INITIAL FIRE SAFETY INSPECTION REPORT

Abir Fashions (Extension)

RSC ID: 24920

Date: 11-Feb-2024

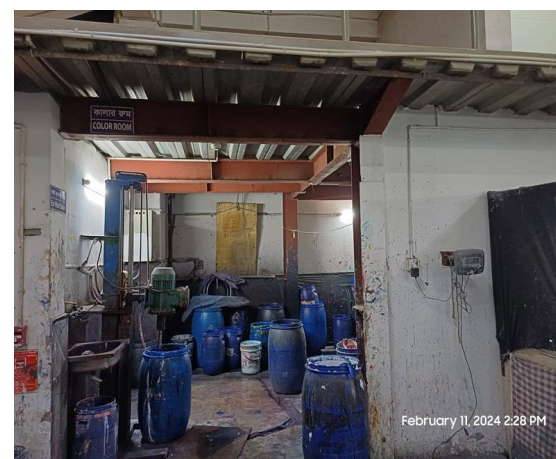
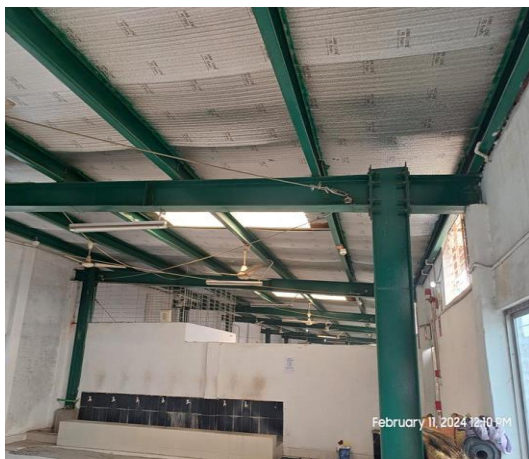
F-2	Fire Rated Construction	Fire doors have been installed in the openings of required fire-rated assemblies such as exit stairs, storage rooms, and other occupancy separations. However, the fire doors were found with the following issues: 1. Doors were kept open by means of door wedges. 2. Doors were not provided with adequate/required hardware. 3. Doors were found with excessive clearance. 4. Doors were not provided with required positive latching. 5. Fire doors and frames were found with holes that could impact the fire protection rating. Locations: Production Building - 5 & 6	Provide minimum 2-hr fire rated separation exit enclosure. Install the fire door as per NFPA 80. Ensure that the fire doors are self-closing and positive latching and that they are provided with fire exit (panic) hardware where serving production floors. If fire doors are required to be held open for functional reasons, provide automatic closing devices tied to the fire alarm system. The clearance under the bottom of a fire door shall be a maximum of 19mm. From edges and top shall be limited to a maximum 4.8 mm. All measurement shall be taken from the "pull side" of the door. Any modification of fire doors beyond the job site preparation shall be approved by the door manufacturer.	Within 3 months

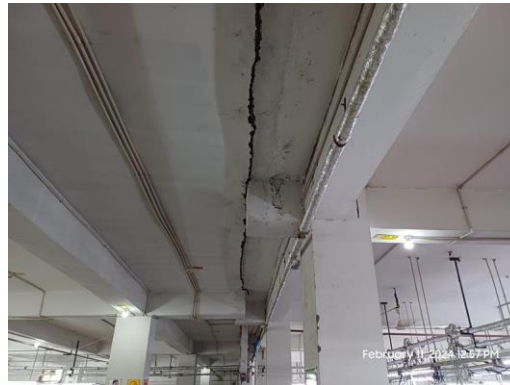
F-7	Fire Rated Construction	Two buildings (Building 5 and Building 6) have construction or seismic joints / expansion joints, located at each floor or ceiling level which is not fire rated separation. Locations: Production Building - 5 & 6	Seal all construction, seismic joint, or expansion penetrations and openings with at least 2-hour fire-rated materials, following ASTM/UL standards and certification.	Within 3 months
-----	-------------------------	--	--	-----------------

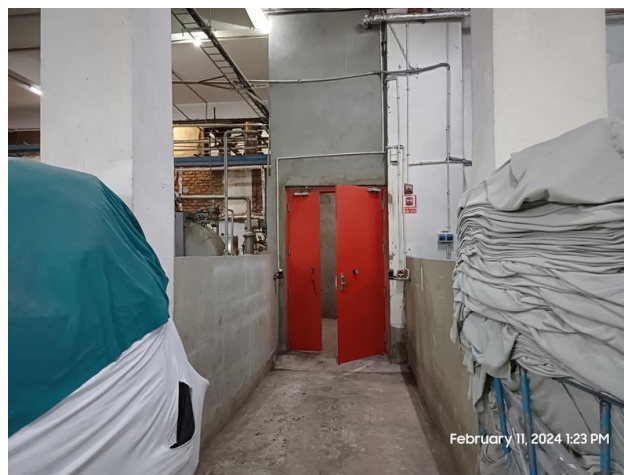
F-9	Fire Rated Construction	Exit stair is discharge the occupants inside the building at the ground floor level. Locations: Production Building - 5 & 6	1. Modify stair to discharge directly outside. Or 2. Provide 2-hr fire-rated exit passageway leading directly outside (vestibules to separate any storage areas). Or 3. Provide sprinkler protection for discharge floor in accordance with NFPA 13.	Within 3 months
-----	-------------------------	--	---	-----------------

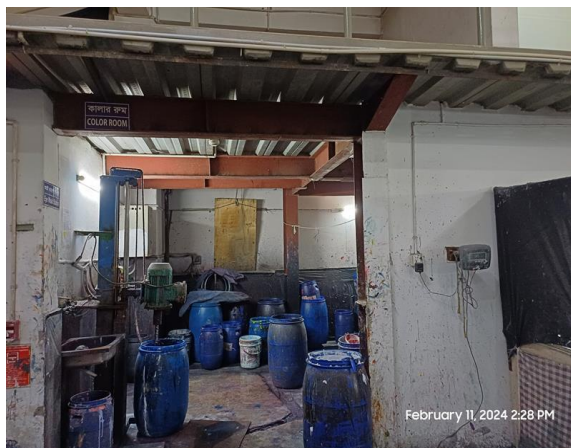
F-10	Fire Rated Construction	The chemical storage area is not separated by fire-rated construction due to unsealed penetrations and openings. Locations: Mezzanine floor of Production Building - 5 & 6	Separate the chemical storage room by 4-hr fire rated construction. Seal all penetrations and protect the openings to maintain the required fire separations. Keep 16-points MSDS of all chemicals in the storage area. Ensure that the building/room houses chemical is Type-1 construction. As per BNBC, chemical storage room shall be Type-1 construction (Table-3.2.4 of BNBC-2006). Follow section-2.13 and Table 3.2.1 of BNBC-2006 for the guideline.	
------	-------------------------	---	---	--

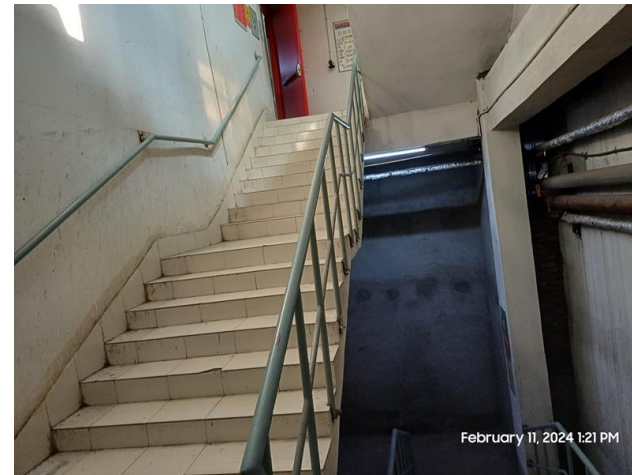
F-18	Means of Egress	Width of exit stair is less than 1.5 m (60 in.). Locations: Production Building - 5 & 6	Provide minimum clear and unobstructed exit stair widths of 1.5 m(60 in.) in accordance with RSC standard 6.5.6.2.1	Within 3 months
------	-----------------	--	--	-----------------

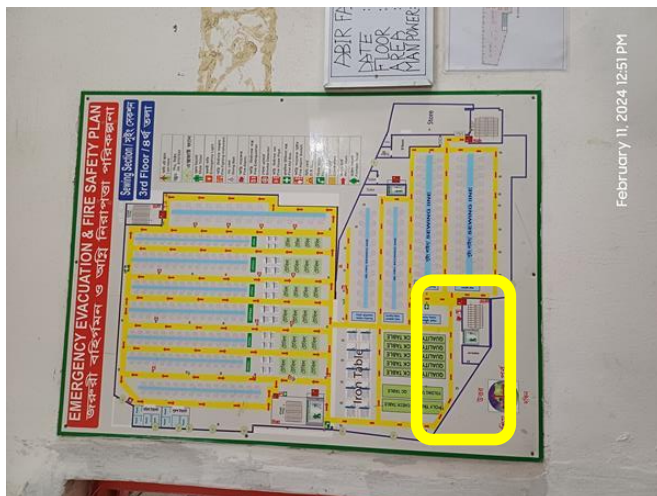
F-20	Means of Egress	Common path of egress travel exceeds the permitted limit at several floor. Locations: Production Building - 5 & 6	Reconfigure the egress arrangement to reduce the maximum common path of travel to not more than 23m (75ft) or 30 m (100 ft) when complete sprinkler protection is provided. [6.13.2- RSC Technical Guidelines Standard V1.0]	Within 3 months

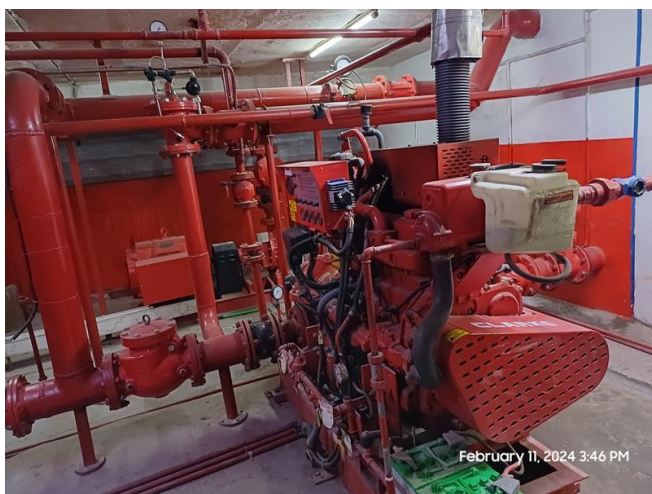
F-28	Fire Protection System (Standpipe)	The height of the highest occupied floor is more than 33 ft and the factory has installed a class III standpipe system which is required to be reviewed and verified. Locations: Production Building - 5 & 6; 7; Production Building - 7; Utility Building.	Submit as-built drawings, testing records, equipment certification and other relevant documentation to the RSC for review and approval. Modification (if required) shall have to be done as per the reviewed design and NFPA- 14. Upon approval & modification (if required) the factory shall inform RSC to conduct final testing and commissioning verification of the system for final acceptance.	Design Review within 2 months and installation/modification within 4 months
------	------------------------------------	---	---	--

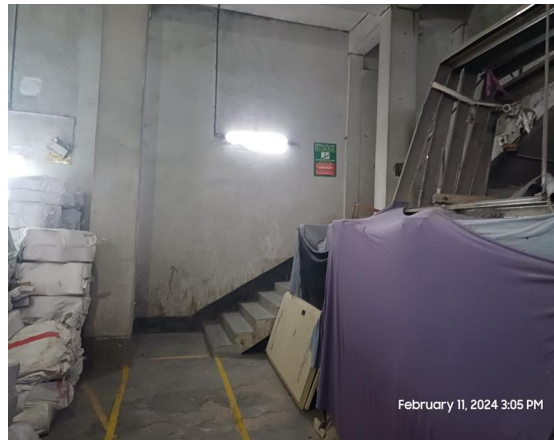
SI No.	Category	Findings	Required Action	Remediation Time Frame
F-33	Fire Rated Construction	The exit stairs are not separated from work areas, other spaces on each floor by fire-rated construction. Locations: Production Building - 7	Provide minimum 2-hr fire rated construction for buildings 4 storied or more and 1-hr for up to 3 storied. Seal all unprotected openings to separate the exit stairs from work areas and other spaces on all floor levels by 90 minutes for 2 hr. construction and 60 minutes for 1-hr construction. Ensure that the fire rated doors are self-closing and positive latching and that they are provided with fire exit (panic) hardware where serving production floors. If fire rated doors are required to be held open for functional reasons, provide automatic closing devices tied to the fire alarm system.	Within 3 months

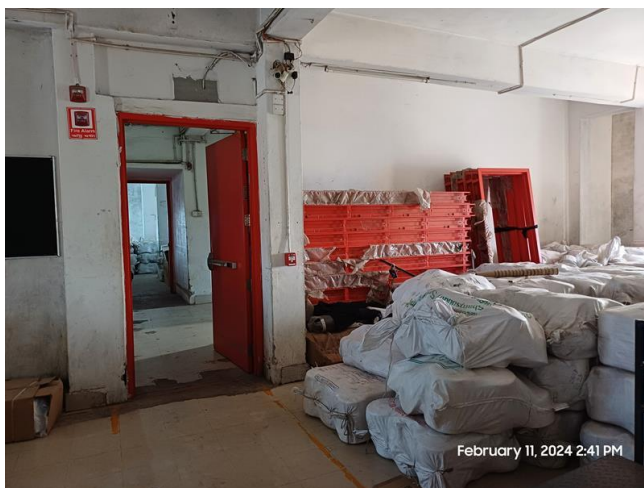
F-35	Fire Rated Construction	Storage room discharges directly into exit stair enclosure. Locations: Production Building - 7	Openings from exit enclosure to storage room, shall be provided with a vestibule with fire rated construction and openings. Provide a 1.5 hr. fire rated door on the exit stair side and a 1-hr. fire rated door on the store side. Ensure that the fire rating of the vestibule construction matches that of the exit stair enclosure.	Within 3 months
------	-------------------------	---	---	-----------------

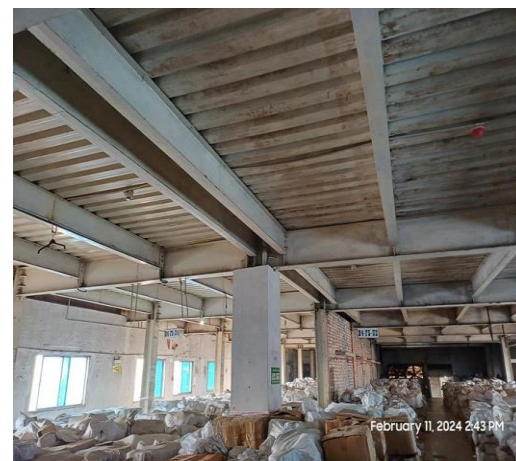
F-36	Fire Rated Construction	The main structural elements of the buildings are constructed by steel which is non-rated and were found in exposed condition without any fire protection. Locations: Production Building - 7	Interim building shall be type-1 or type-2 construction as per Table 3.2.4 of BNBC-2006. Provide required fire rating on the structural elements by following Section 4.4 and Table 4.4.1 of the RSC Technical Guidelines Standard or Table 3.3.1 and Table 4.1.1 from BNBC Part 4. Consult a qualified fire protection engineer to design the rated construction barriers in between two floors and in structural members.	Within 6 months
------	-------------------------	--	--	-----------------

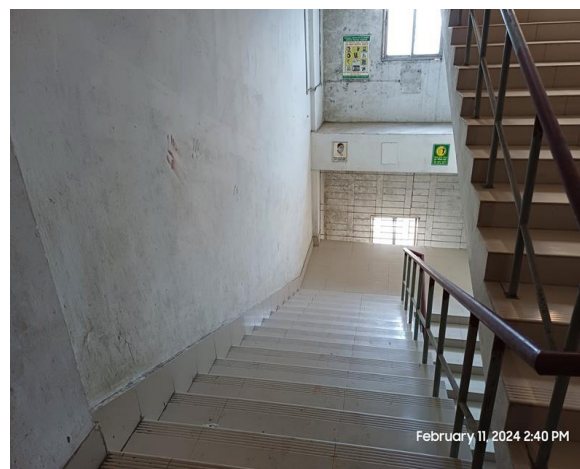
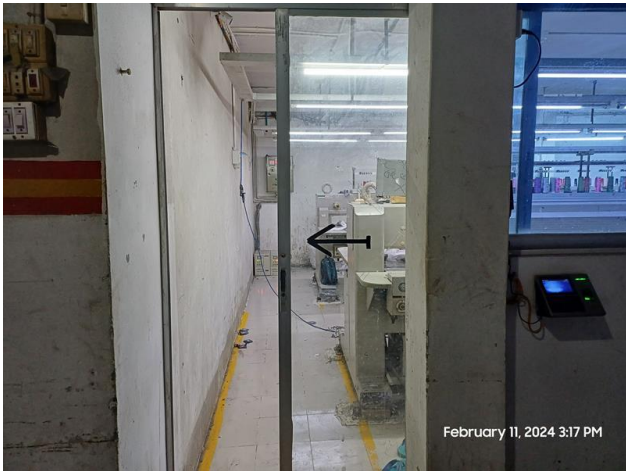
F-43	Means of Egress	Handrails are not provided on both sides of both exit stairs. Locations: Production Building - 7	Provide handrails on both sides of the exit stair. New handrails shall have a minimum height of 865 mm (34 in.) and a maximum height of 965 mm (38 in.) as measured from the leading edge of the tread. Intermediate handrails shall be provided when the stair width exceeds 2.2 m (87 in.). Rail guards shall be such patterned so that a sphere 200mm (8 in.) in diameter cannot pass through any opening up to a height of 865mm (34in.).	Within 3 months
------	-----------------	---	---	-----------------

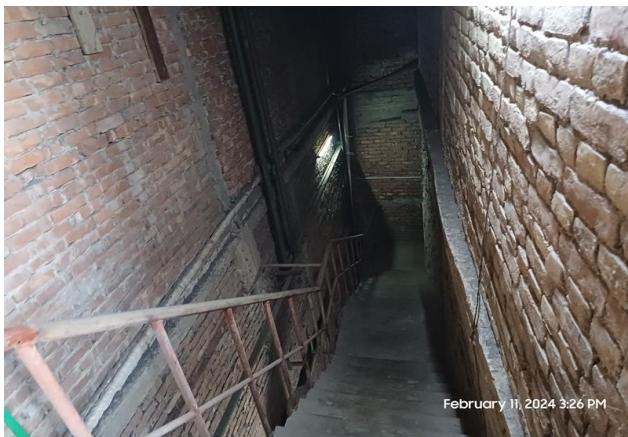
F-47	Egress Lighting	Based on the number and location of emergency lights observed, adequate illumination levels are not anticipated along egress routes and at exit stairs on all floors. Locations: Production Building - 7	Test the emergency lighting system on each floor and provide additional emergency fixtures to supply adequate illumination along the means of egress. Provide a minimum illumination of 10 lux at the floor level within exit stairs and along exit discharge paths and a minimum 2.5 lux along exit access aisles.	Within 1 month
F-48	Egress Lighting	Exit sign and Directional Sign are not provided at and towards exit at several floors. Locations: Production Building - 7	Lighted exit signs shall be placed at entrance to an exit. Additional exit signs shall be placed throughout the facility anywhere the continuation of the egress is not obvious. Lighted exit signs shall be provided with either battery backup or uninterruptable power supply systems and shall be continuously illuminated.	Within 1 month

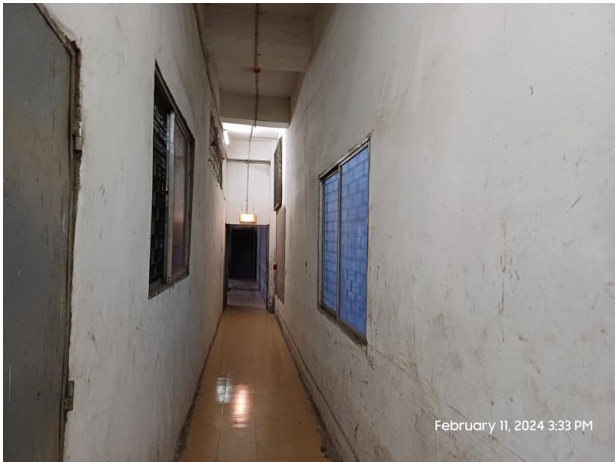
SI No.	Category	Findings	Required Action	Remediation Time Frame
F-49	Fire Rated Construction	The exit stairs are not separated from work areas, other spaces on each floor by fire-rated construction. Locations: Utility Building	Provide minimum 2-hr fire rated construction for buildings 4 storied or more and 1-hr for up to 3 storied. Seal all unprotected openings to separate the exit stairs from work areas and other spaces on all floor levels by 90 minutes for 2 hr. construction and 60 minutes for 1-hr construction. Ensure that the fire rated doors are self-closing and positive latching and that they are provided with fire exit (panic) hardware where serving production floors. If fire rated doors are required to be held open for functional reasons, provide automatic closing devices tied to the fire alarm system.	Within 3 months

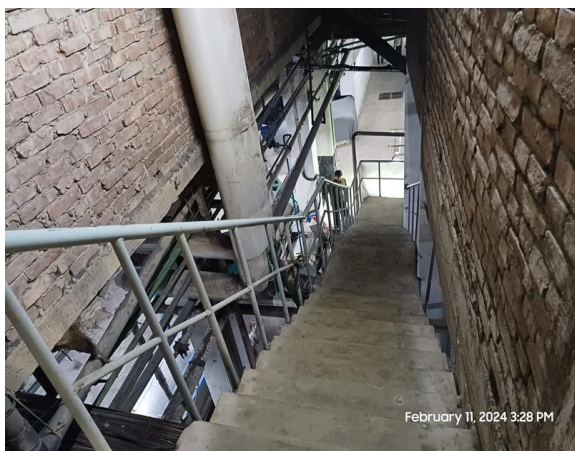
F-51	Fire Rated Construction	Exit stair is discharge the occupants inside the building at the ground floor level. Locations: Production Building - 7	1. Modify stair to discharge directly outside. Or 2. Provide 2-hr fire-rated exit passageway leading directly outside (vestibules to separate any storage areas). Or 3. Provide sprinkler protection for discharge floor in accordance with NFPA 13.	Within 3 months
------	-------------------------	--	---	-----------------
